# Access Compliance Report

### (Curb Ramps)

Intersection ID: 47775	Main Street: BEREWICK COMMONS PKY	Cross Street: TRAILMOOR RD	Location: SE
ADA ID: 62E97D749B6A	Ramp Type: PerpDiag	Initial Pass/Fail: Fail	Overall Compliance: No
Severity Score: 22.5			
Codes/Mitigation Info/Possible Solution		Field Measurements/Component Compliance

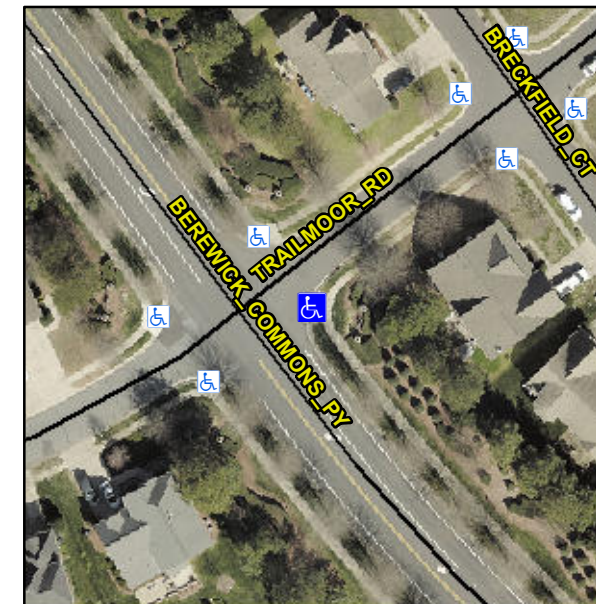
**Not Found, R304.5.1, R304.2.2, R304.5.3**

Compliance	Description	Data	Compliance	Description	Data
N/A	Ramp Length (in)	66.0	No	Ramp Slope (%)	8.6
No	Ramp Width (in)	47.0	No	Ramp XSlope (%)	3.5
N/A	Flare Type LT	N/A	N/A	Flare Type RT	N/A
N/A	Flare Slope LT (%)	N/A	N/A	Flare Slope RT (%)	N/A
N/A	Flare Traversable LT?	N/A	N/A	Flare Traversable RT?	N/A
N/A	Landing Length (in)	N/A	N/A	DWS Provided?	N/A
N/A	Landing Width (in)	N/A	N/A	DWS Contrast?	N/A
N/A	Landing Slope (%)	N/A	N/A	DWS Length (in)	N/A
N/A	Landing X Slope (%)	N/A	N/A	DWS Full Width?	N/A
N/A	Landing Curb? (Y/N)	N/A	N/A	DWS Offset (in)	N/A
N/A	Shared Landing?	N/A			
N/A	Gutter Ponding?	N/A	N/A	Gutter Slope (%)	N/A
N/A	Gutter Lip Ht (in)	N/A	N/A	Gutter X Slope (%)	N/A
N/A	Painted X Walk1?	No	N/A	Painted X Walk2?	No
	X Walk 1 Direction	To NW		X Walk 2 Direction	To SW
N/A	X Walk 1 Width (in)	N/A	N/A	X Walk 2 Width (in)	N/A
	X Walk 1 Slope (%)	4.6		X Walk 2 Slope (%)	0.4
	X Walk 1 X Slope (%)	1.7		X Walk 2 X Slope (%)	3.0

**Remove & Replace Curb Ramp With Two New Directional Ramps or Equivalent.**
